**TITLE: AIRBORNE AUXILIARY POWER - CONTROL AND MONITORING -
MODIFY ELECTRONIC CONTROL BOX (ECB) SOFTWARE FOR
HONEYWELL APU 131-9A.**

MODIFICATION No.: 155015G0840 155095G0889

This page transmits Revision No.02 of Service Bulletin No.A320-49-1107

SERVICE BULLETIN No.: A320-49-1107

Figure A-SSAAA - Sheet 01
- Location of the ECB

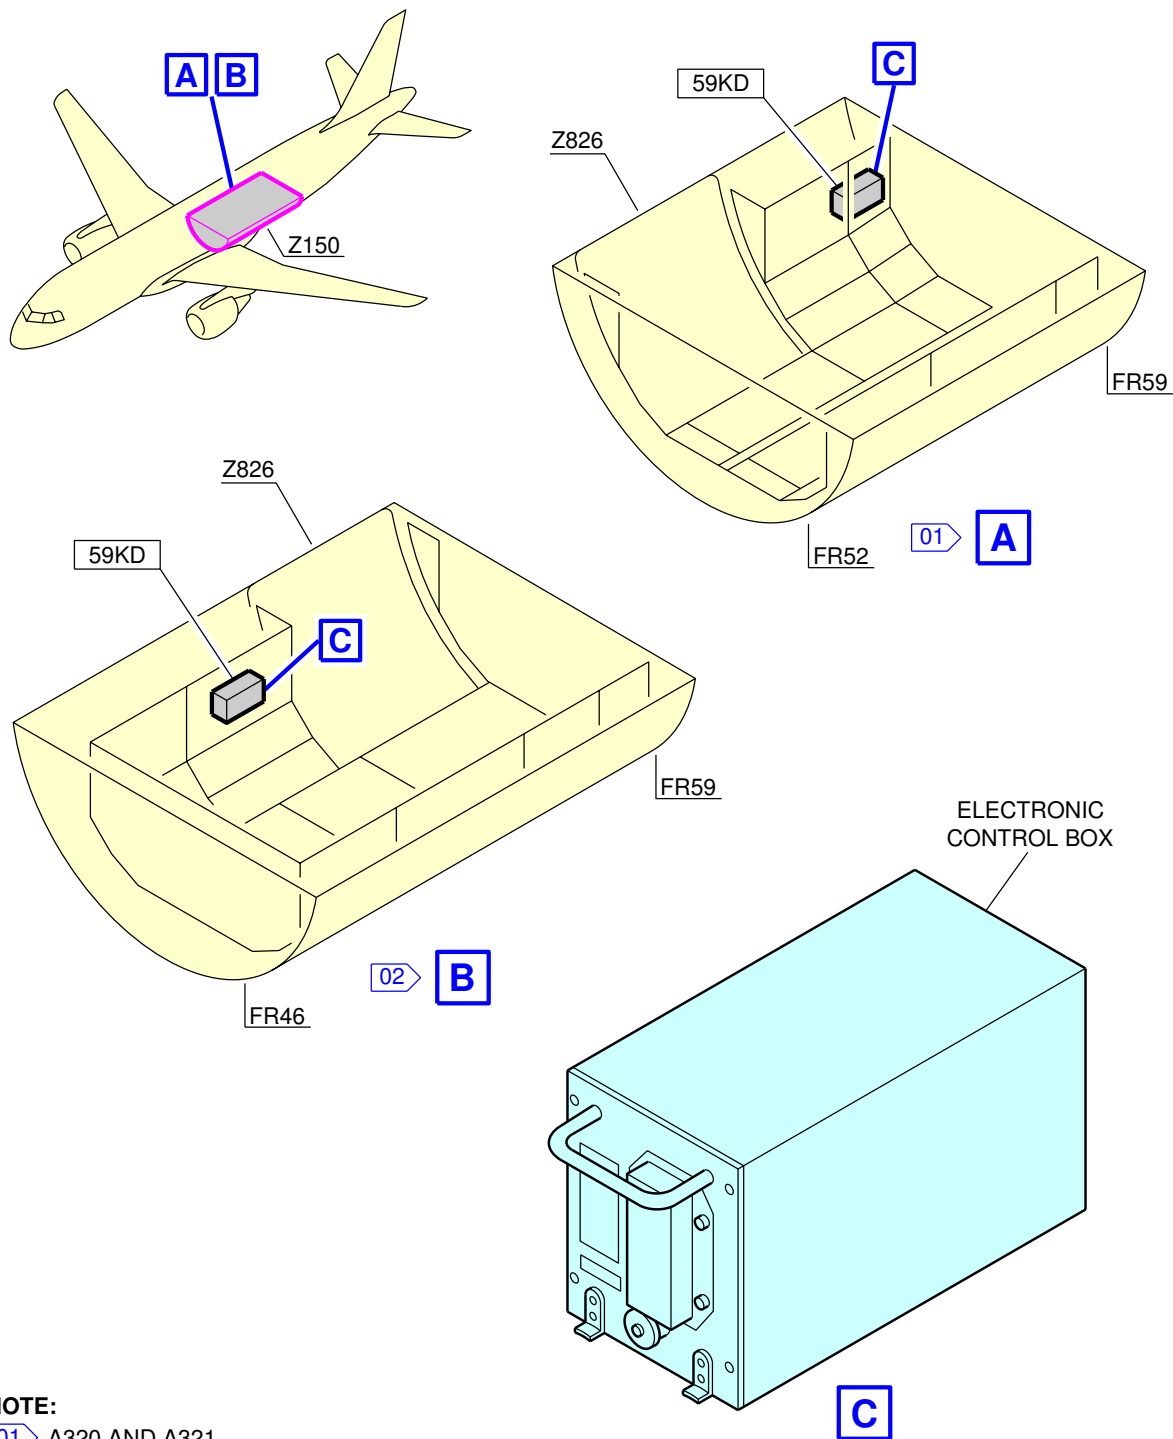
Honeywell Auxiliary Power Unit (APU) 131-9A Electronic Control Box (ECB) experiences data saturation of APU hours and cycles, which are not transmitted after 16383.

ECB software modification is proposed to address the hour/cycle data saturation and to expand tracking capability up to 131071 hours/cycles. The modification comprises the incorporation of two additional variables for hours and cycles with an increased range. The data will be transmitted via Aeronautical Radio Incorporated (ARINC) 429 (Labels 135 and 136) and stored in Data Memory Module (DMM).

The accomplishment of this Service Bulletin will expand the tracking capability of the ECB from 16383 to 131071 hours/cycles.

Figure A-SBAAA - Sheet 01
Location of the ECB

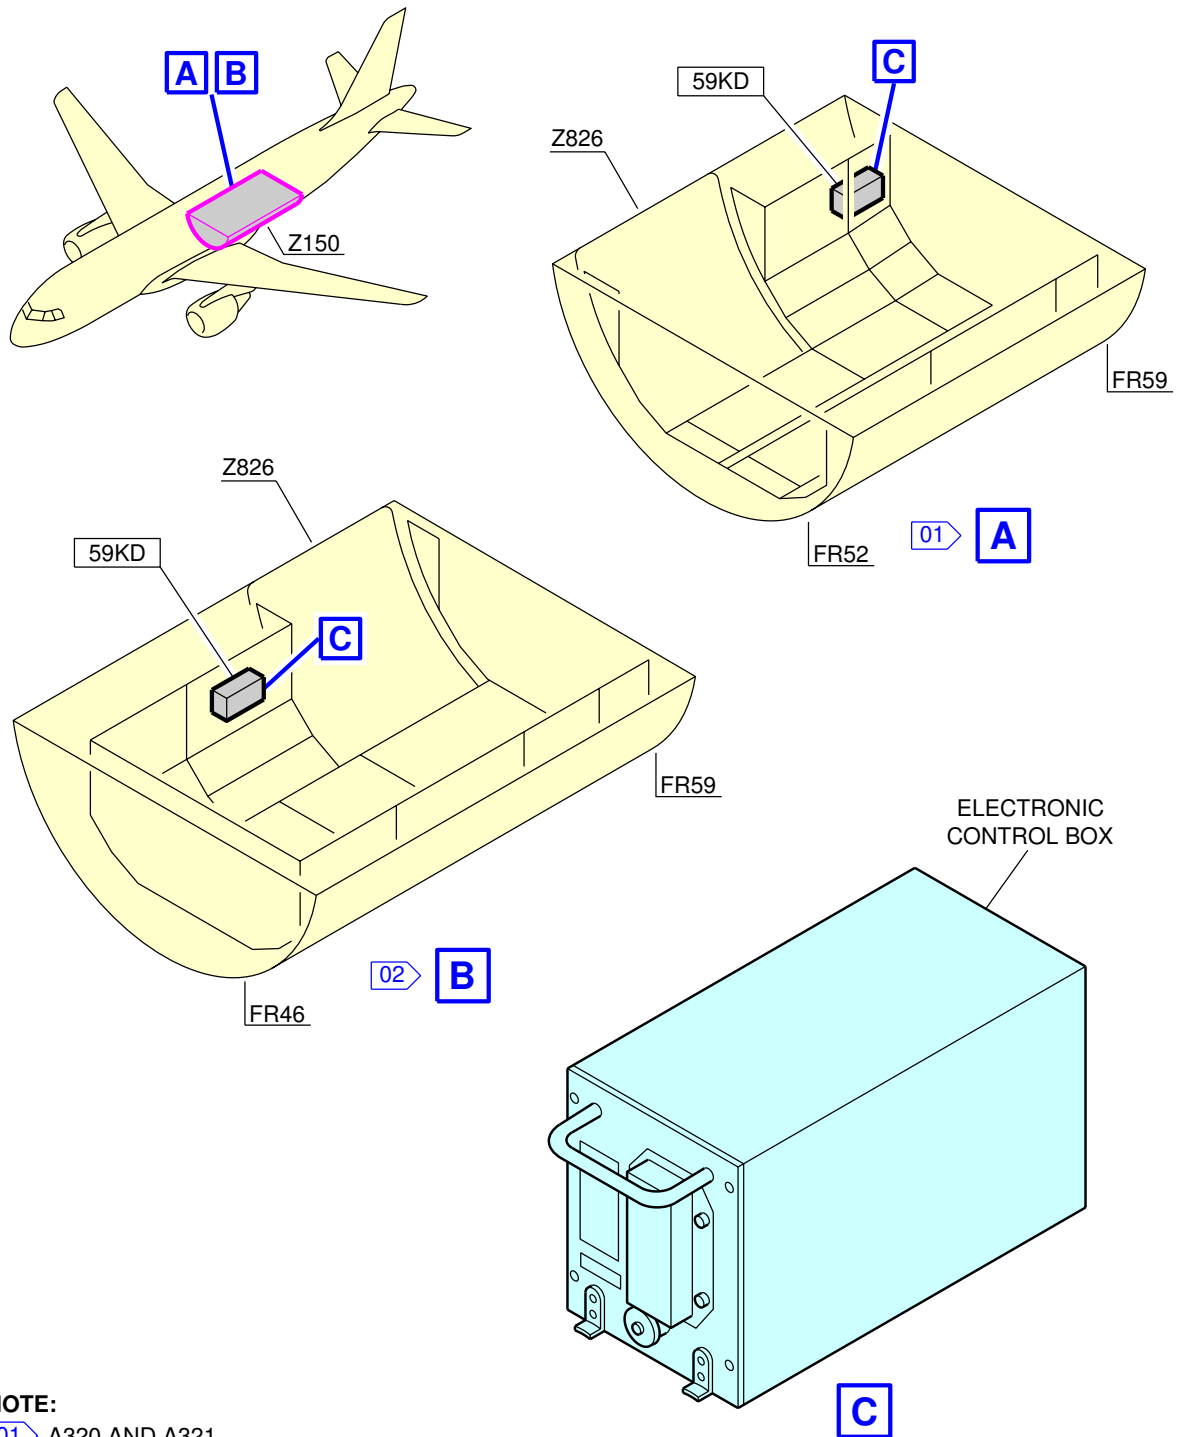
- (a) Remove the ECB from the aircraft, refer to AMM Task 49-61-34-000-003-A and HONEYWELL Service Bulletin No. 131-49-8104:

- (a) Remove the ECB from the aircraft, refer to AMM Task 49-61-34-000-003-A:
